BusConnects Dublin Core Bus Corridor Projects

Corridor 14 – UDC to Ballsbridge

Emerging Preferred Route – Public Consultation Report 2018/2019

Figure 3: Section 1 UCD to Nutley Lane

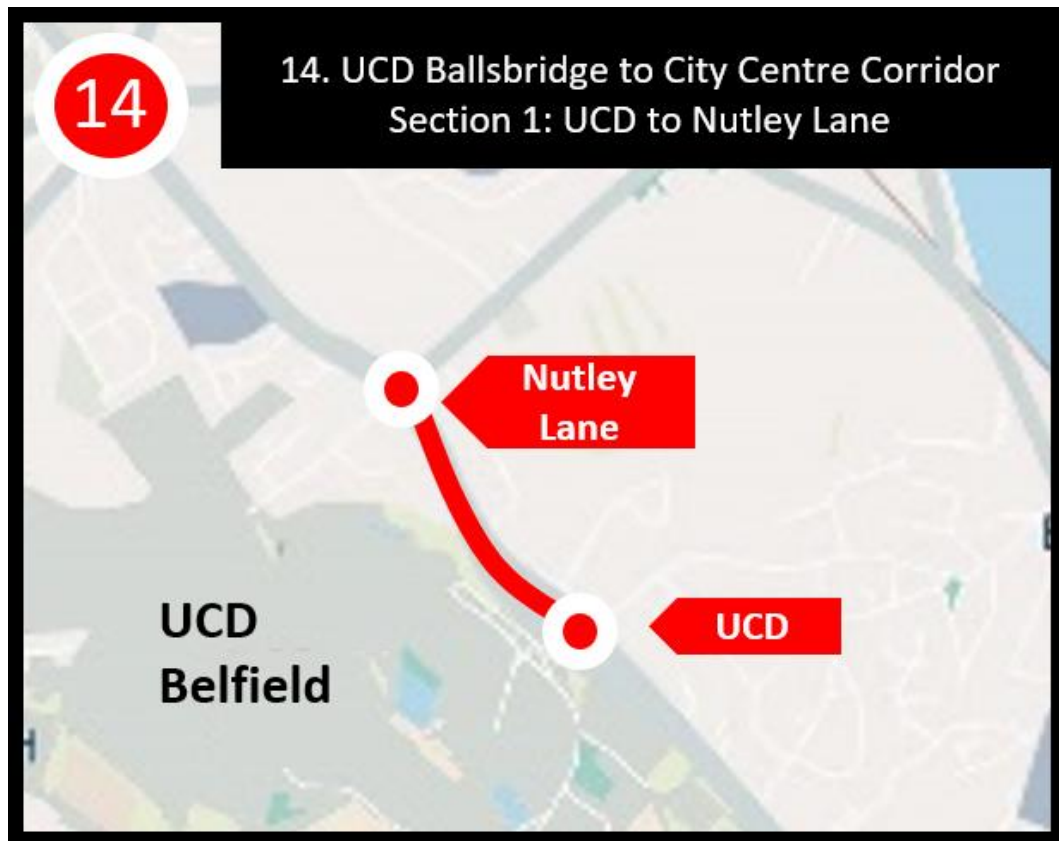
- A concern which arose in submissions generally related to Nutley Lane, the right-turn movement of buses from the R138 at the western extent of Section 1. Although it was detailed in the public consultation drawings it is viewed as being potentially unsafe and unclear, given the need for a bus to stay left and then cross three lanes of traffic into town.

Figure 4: Section 2 Nutley Lane

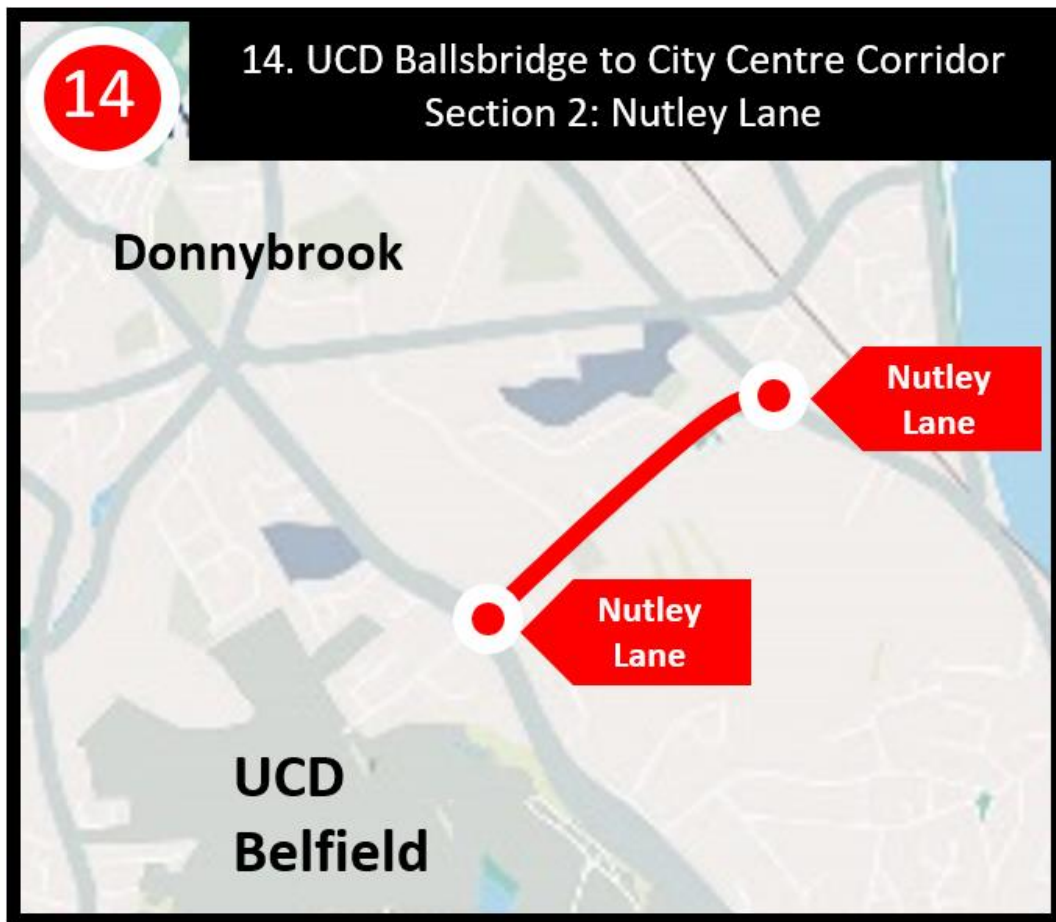
- A large number of submissions were based around the likely increase in the cross section of what is currently perceived as a residential road with through traffic. Concerns regarding a potential induced demand effect were raised, citing traffic studies which have shown that road widening does not always provide long term increased capacity – and a number of submissions suggested that the presence of a junction on each end of the road could possibly negate the additional capacity provided. Some residents proposed alternative arrangements such as reducing the proposed cross section to two bus lanes, and a single traffic lane (perhaps from R138 as far as the Hospital entrance, then becoming two-way, or alternating eastbound and westbound in AM and PM), along with other potential amendments such as a single two-way cycle track on the Elm Park side or having no footpath provision from Elm Park Golf Club Entrance to the Hospital entrance (on east side) as the main demand on this side is from those parking.

- The removal of on-street trees and those in front gardens was highlighted as a concern amongst residents. The concerns relate mainly to aesthetics of area, environmental concerns (both carbon absorption and biodiversity aspects), and the coverage provided from sun and rain. Alternative suggestions included a recommendation to create a central median with linear mature trees in a boulevard cross section, with land take for same focussed on the Elm Park side. Many submissions note that there is little evidence of new trees being provided like-for-like or a compensatory planting strategy.

- There were concerns expressed that sufficient detailed surveys have not been carried out to permit proceeding with the plan, including socio-economic, traffic, topographical, environmental, and underground services.

- Likewise, a number of submissions question the need for both cycle and bus provision on Nutley Lane, with alternative suggestion for cycle lanes being Woodbine Road or Booterstown Avenue.

- It is stated on a number of occasions that there are historic streams / rivers in this area, many of which have been culverted, and possibly a high-water level. Some submissions have expressed concerns of flooding given the proposed increase in hard standing area associated with this plan. There were some related concerns about access to the various services including these culverts

- A number of residents were also concerned with the locations and number of bus stops, suggesting the possible added noise and vibrations so close to residential homes could be disruptive.
- Some submissions raised concerns with regard to potential impacts on local sports facilities.

Figure 5: Section 3 Nutley Lane to Sandymount Avenue

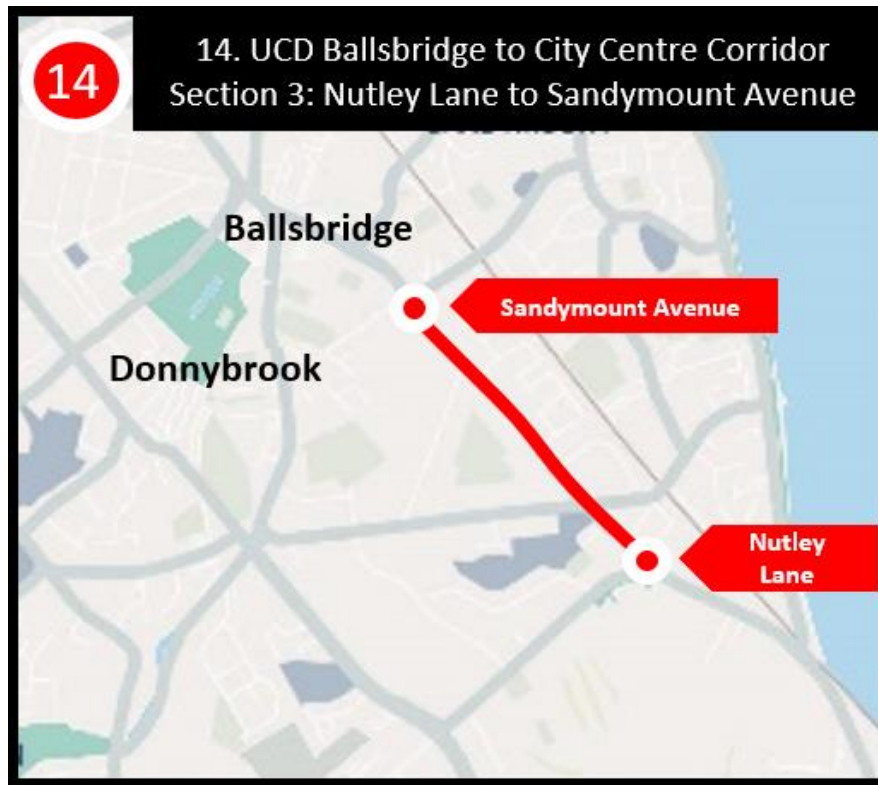
- The potential removal of on-street mature trees and those in front gardens was also a cause for concern amongst residents. The concerns relate mainly to aesthetics of area, environmental concerns (both carbon absorption and biodiversity aspects), and the coverage provided from sun and rain. Many submissions suggested that there is little evidence of new trees being provided like-for-like or a compensatory planting strategy.

- It was claimed in some submissions that although there were tree report and surveys carried out, the results do not consider the higher level environmental benefits of urban trees. Submissions referenced examples such as the current funding programme in the UK for planting of trees in urban areas to mitigate rising temperatures, and a Dutch study which supported this thinking in showing that tree shading of hard standing can reduce local summer temperatures.

- There were concerns raised that existing bus routes will be lost, and the proposed services are either not sufficient or the plans provided do not detail them enough to alleviate concerns. In particular the 1 and 47 are noted as valuable local services that are used by many locals and not just commuters. The 17 and 18 are also noted as well used local buses.

- It is suggested that the current plans indicate the closure of an entrance to an established access to the back of some residential properties on Merrion View Avenue, and that no alternative is indicated. It was suggested that this is an established right of way which is heavily used.

- Some concerns were expressed that sufficiently detailed surveys have not been carried out to permit proceeding with the plan, including socio-economic, traffic, topographical, environmental, and underground services.

Figure 6: Section 4 Sandymount Avenue to Shelbourne Road

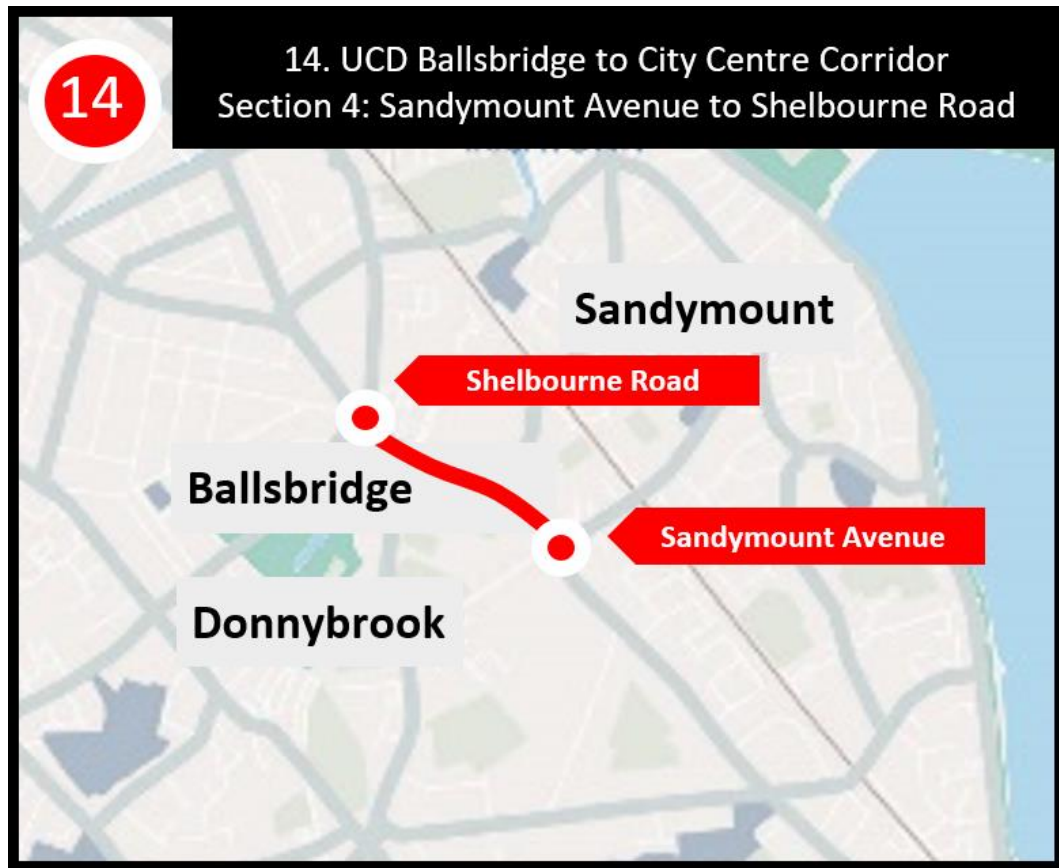
- The removal of the left turn movement onto Elgin/Clyde Road is queried and there are also alternative suggestions that Herbert Park be made a no through road rather than Eglin/Clyde Road to enhance the park function and remove cars.

- As with other sections, the removal of on-street mature trees and those in front gardens was highlighted as a cause for concern amongst residents. The concerns relate mainly to aesthetics of area, environmental concerns (both carbon absorption and biodiversity aspects), and the coverage provided from sun and rain. It is suggested that in particular in the Ballsbridge area the trees form an important part of the history and lives of those living in the area. Many submissions note that there is little evidence of new trees being provided like-for-like or a compensatory planting strategy. It is also claimed that the public consultation maps are seen as misleading as regards trees to be retained, as it is not made clear that many of them on the drawing are in private lands.

- A significant number of submissions were based around the potential increase in the road cross section (often suggesting that it is at the expense of trees) and the justification / options assessment for this proposal. There were concerns raised that one bus lane could be empty in the morning and the other empty in the evening, and therefore the construction cost of the road widening is suggested as waste of public expenditure. Alternative suggestions include three lanes with two lanes inbound in the morning and two lanes outbound in the evening, combining cycle facilities into a single narrower two-way cycle track, increased rail capacity, softer measures such as congestion charges, carpooling and banning cars from City Centre.

Figure 7: Section 5 Shelbourne Road to Eastmoreland Place

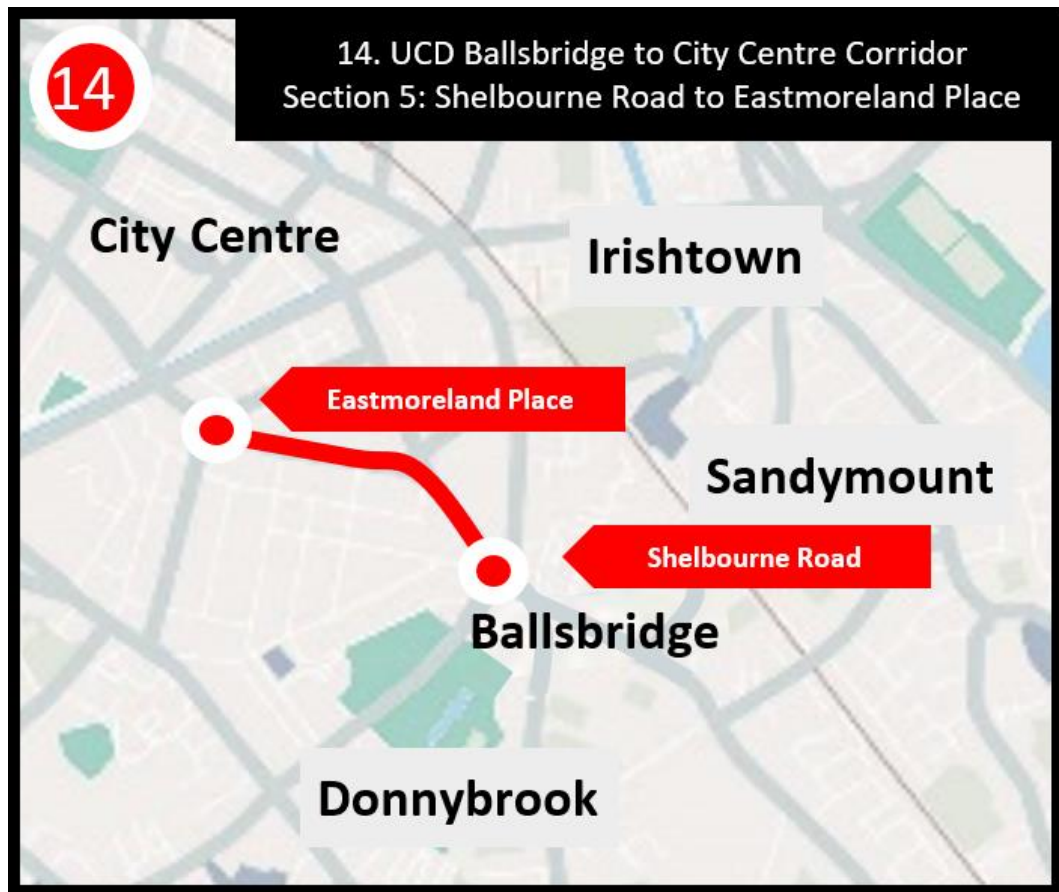
- The removal of parking and conversion into 24-hour bus lanes is claimed to completely remove the ability of residents with no driveways to have home deliveries, to place a skip in front of their home, or have temporary scaffolding erected, which are of particular concern to those living in protected structures which by law they are required to maintain.

- A number of submissions questioned the options assessment and data collection process in determining the route and the proposed cross section as being the preferred option over all alternatives. There is a perceived lack of information on the assessment and a perceived lack of justification / supporting evidence for the works – and a fear that if this solution is carried out and is then determined to not be fit for purpose, the possible impact will be irreversible. A number of alternatives were suggested such as underground public transport, cable-car type systems, rerouting of cyclists, allowing use of bus lanes by car sharing vehicles, reducing cross section and altering direction of travel in opposing peaks, amongst others.

- There were concerns expressed that sufficiently detailed surveys have not been carried out to permit proceeding with the plan, including socio-economic, traffic, topographical, environmental, and underground services. The actual congestion on Pembroke Road was queried, with the claim that An Garda Síochána regularly place speed detection vans on the road.

- There were concerns expressed in relation to the potential relocation of the kiosk at the Pembroke Road / Northumberland Road junction as it is suggested that it forms part of the fabric of the area.

Figure 8: Section 6 Eastmoreland Place to Baggot Street Lower

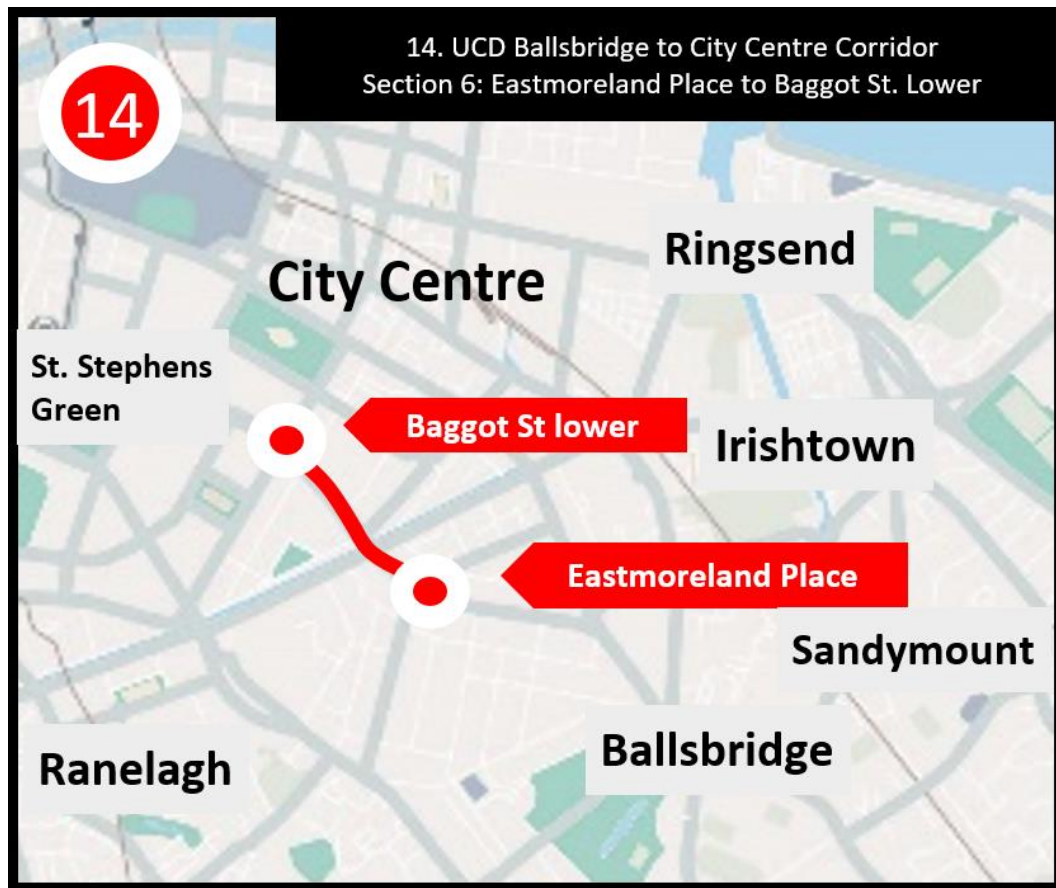
- There were some concerns raised that the plans may not make it any safer or attractive for cycling, as one of the main detractors from cycling is the fumes from cars and buses. A number of submissions opposed the non-segregated nature of the cycle provision and the need to mix with bus and vehicular traffic. It is suggested that an alternative cycle route through safer streets be developed.

- A number of submissions questioned the options assessment and data collection process in determining the route and the proposed cross section as being the preferred option over all alternatives. There is a perceived lack of information on the assessment and a perceived lack of justification / supporting evidence for the works – and a fear that if this solution is carried out and is then determined to not be fit for purpose, the impact will be irreversible. The proposals are suggested by some as a short-term solution and other alternatives such be considered such as underground metro, underground road network, congestion charges, taxing free parking spaces, or increasing park-and-ride facilities.

- The proposed routing of buses along Baggot Street is questioned, mainly in relation to what is planned for buses approaching Baggot Street / Fitzwilliam Street junction (end of Route 14) and how the tie-in to the existing cross section could potentially create bottlenecks and detract from the time savings achieved.

- Numerous submissions suggest that there is little evidence of new trees being provided like-for-like or a compensatory planting strategy. It is also suggested that the public consultation maps were seen as misleading with regards to trees to be retained, as it was not clear if many of them on the drawing are in private lands and that the maps do not indicate the trees which are being removed. Some submissions suggested that the trees being removed are known and should be highlighted on the drawings to describe the true impact.
